RE: ESD Referral - 123 Bradshaw Street, Essendon - MV 818/2016 - 3 dwellings - STORM+BESS

DWGS: sheets 01-10, rev 12/09/2016, by Ultimate Design – missing following information:

Please refer to the accompanying**Proposed Ground Floor PlanTown Planning Drawing 12/9/2016 (the plan).**

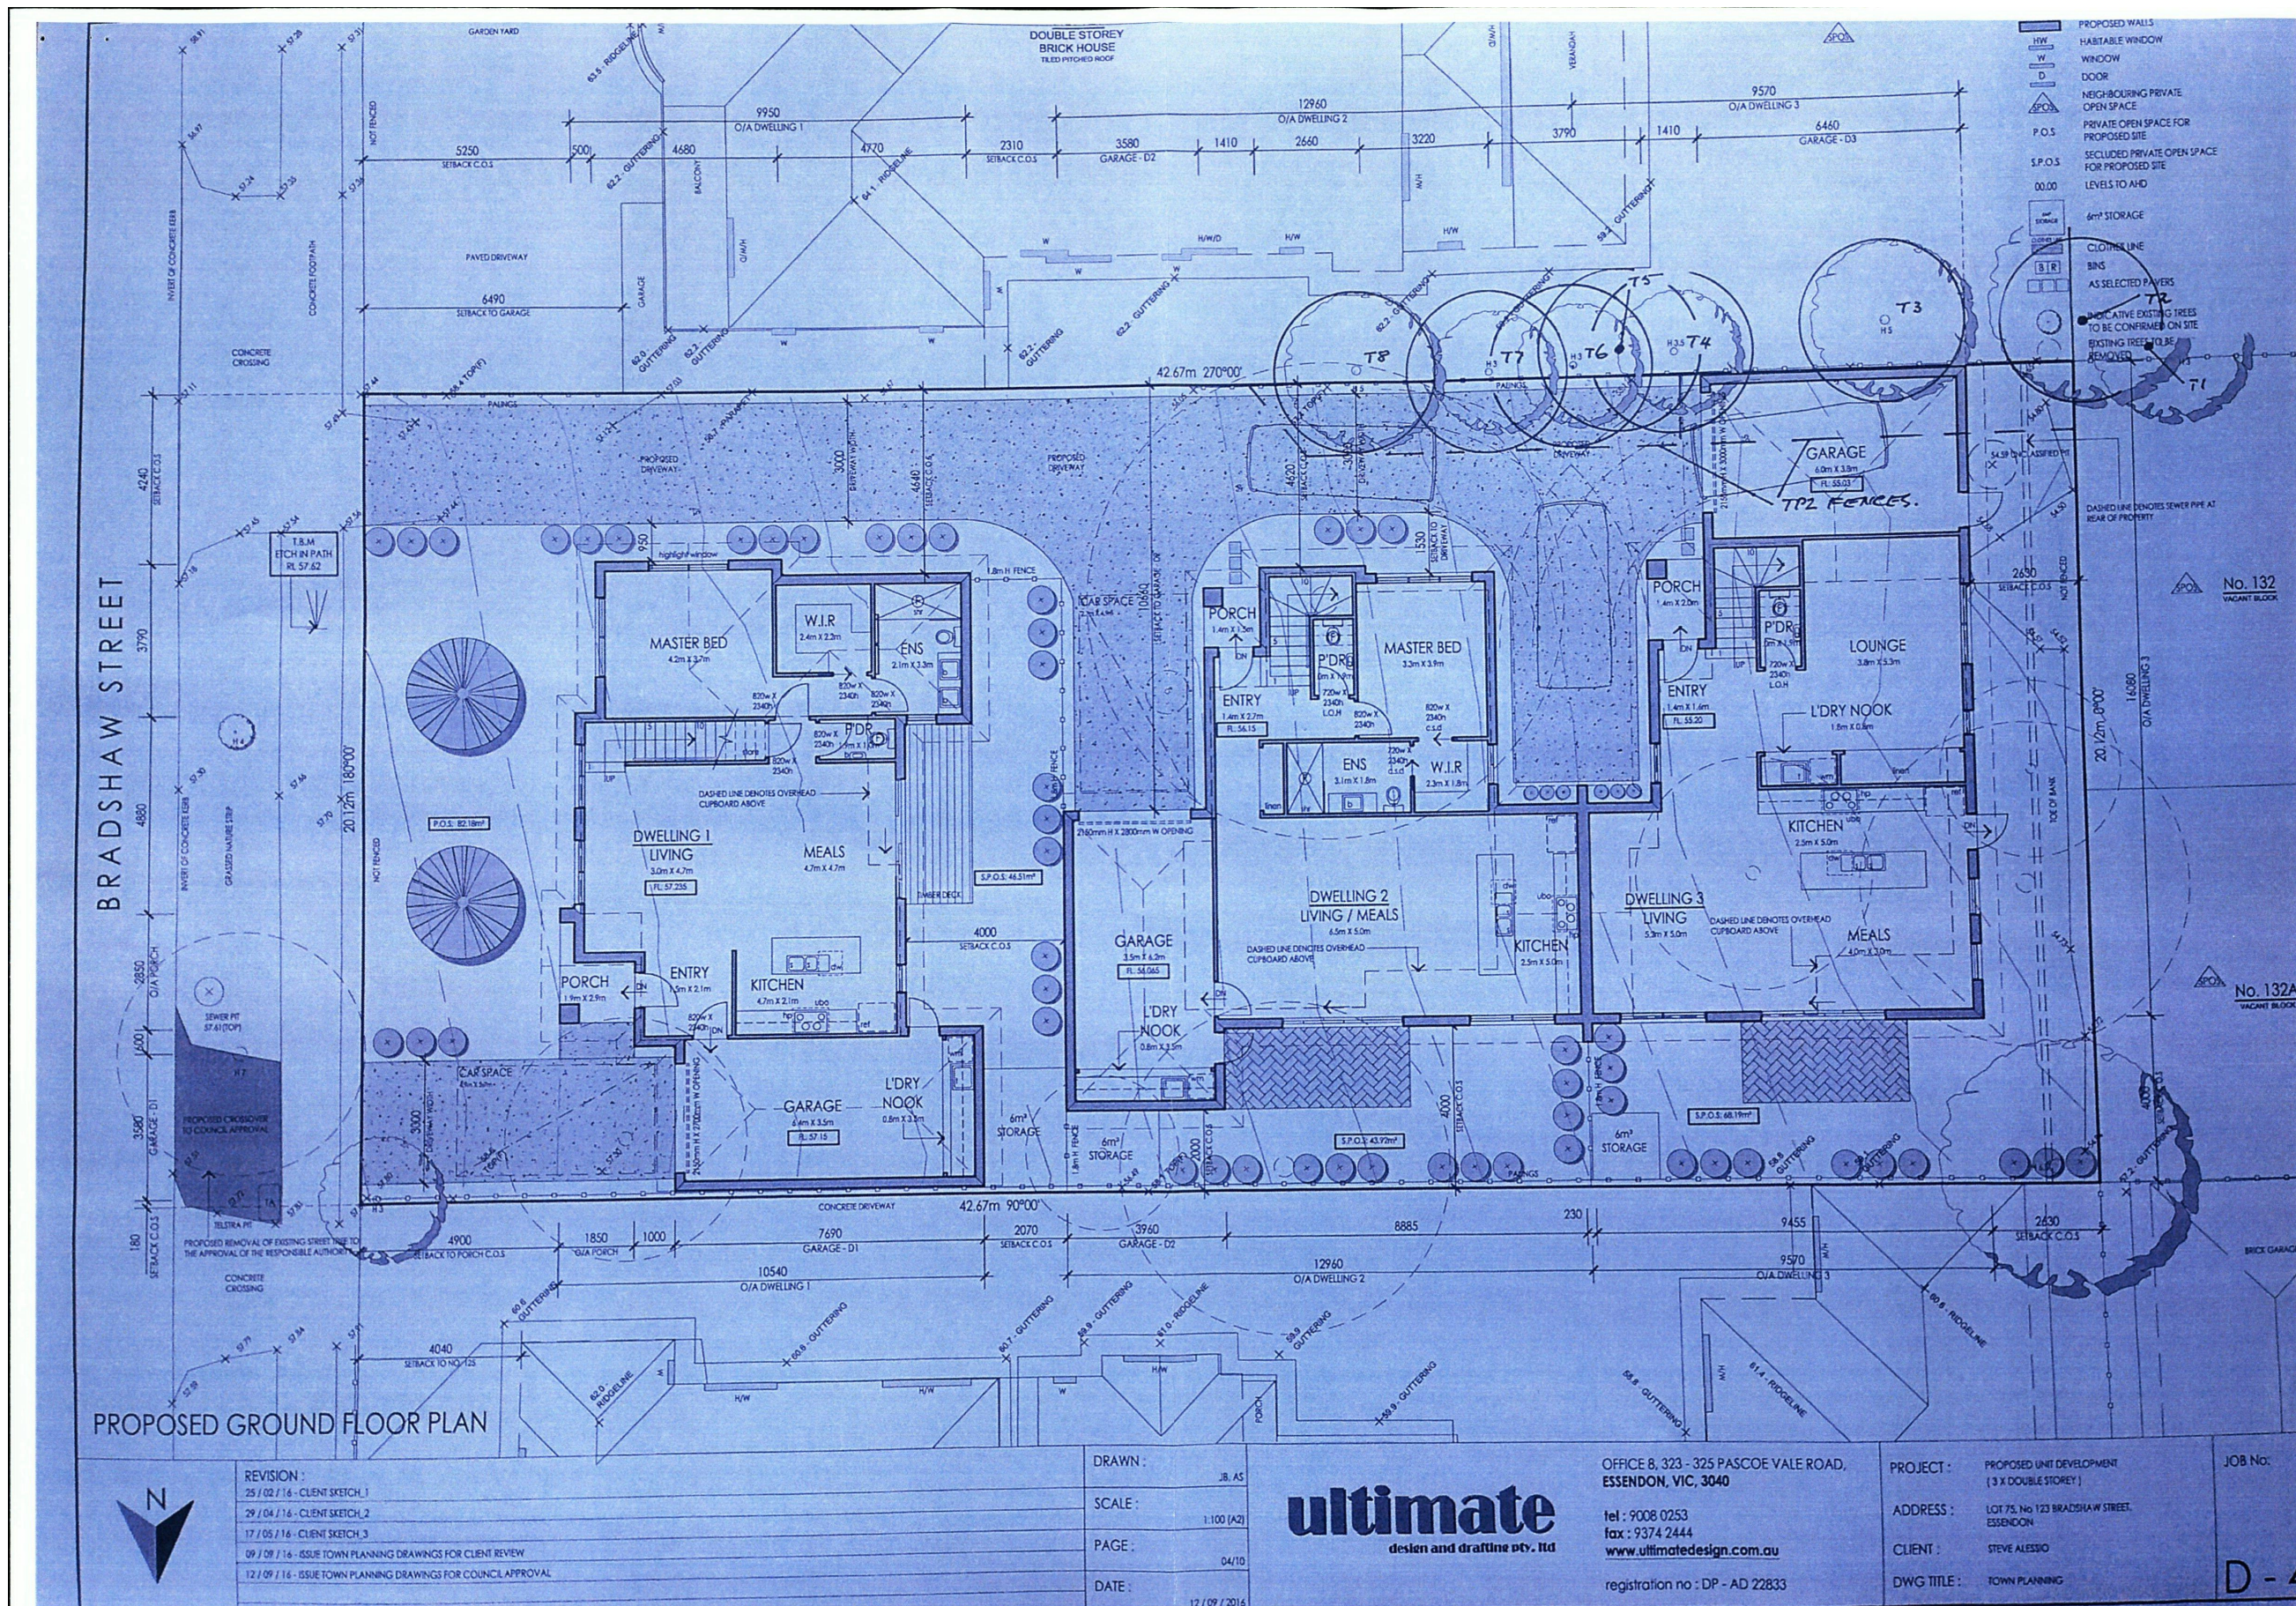
Excavation for the footings of the Unit 3 garage would encroach on the TPZ of T3 by about 2.1m², or about 16.6% of the TPZ area. There would also be encroachment into the SRZ.

To reduce the impact of the encroachment on the tree, and move the excavation outside the SRZ, the edge beam of the slab must be moved 500mm North of the Southern property boundary. The slab can then be cantilevered over the beam.

Excavation for the footings of the Unit 3 garage would encroach on the TPZ of T4 by about 1.1m², or about 8.7% of the TPZ area. There would also be encroachment into the SRZ.

Paving of the proposed driveway to the Unit 3 garage would encroach on the TPZ of T4 by about 2.4m², or about 19% of the TPZ area.

Paving of the proposed driveway to the Unit 3 garage would encroach on the TPZ of T5 by about 2.8m², or about 22% of the TPZ area.

Paving of the proposed driveway to the Unit 3 garage would encroach on the TPZ of T6 by about 3.9m², or about 31% of the TPZ area.

Paving of the proposed driveway to the Unit 3 garage would encroach on the TPZ of T7 by about 4.7m², or about 37% of the TPZ area.

Paving of the proposed driveway to the Unit 3 garage would encroach on the TPZ of T8 by about 4.3m², or about 34% of the TPZ area.
